Re: SSD 9835 Sydney Football Stadium Redevelopment – Condition B8(a) and (b) aero-acoustic report

Aero Acoustic Report – Design Impacts

ARCHITECTURAL SERVICES -
FACADE DETAIL - SUNSHADE
DETAILS SHEET 03

Design Confirmation – Structural Requirements set out in Aeroacoustic Report

Drawing Title
**SYDNEY FOOTBALL STADIUM
PERFORATED SHEET**

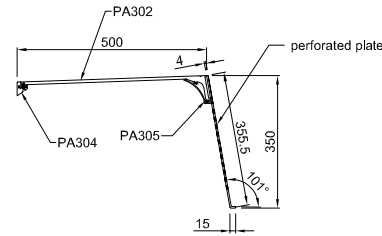
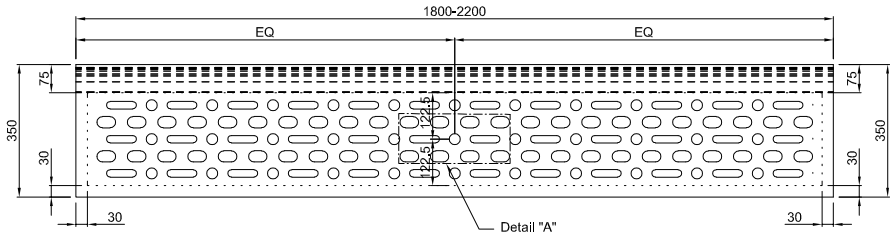
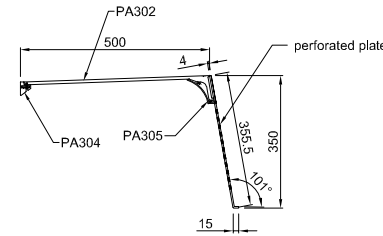
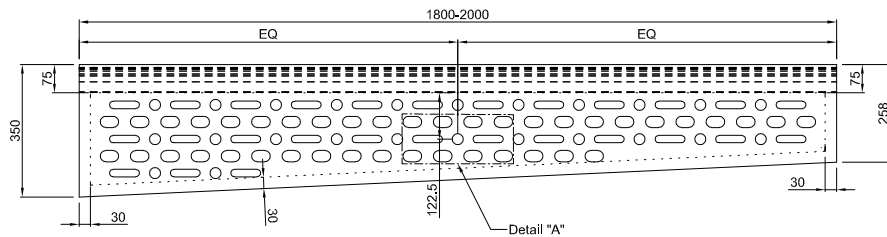
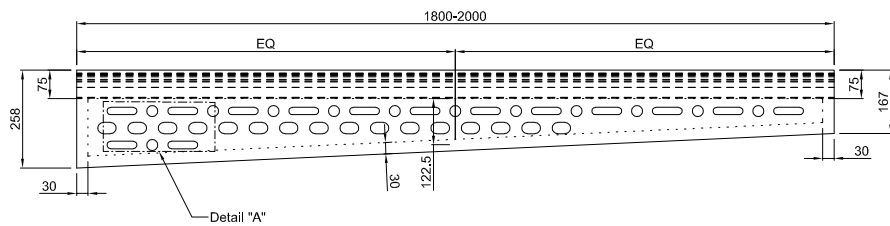
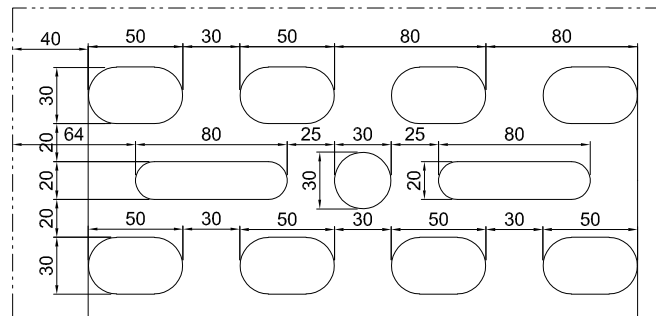
FINALISED PERFORMANCE DESIGN AS PER MITIGATION SECTION OF RWDI REPORT.

Permasteelisa Group aimed to satisfy architectural intent with perforation proposals. The final development – refer SK200826-1_Perforated Option1-00.pdf, was accepted Architecturally and satisfied Aeroacoustics as referenced in section 6 “Mitigations” "201009 RWDI Project 2000267 Sydney Football Stadium - Aeroacoustic Assessment Final Report.pdf"
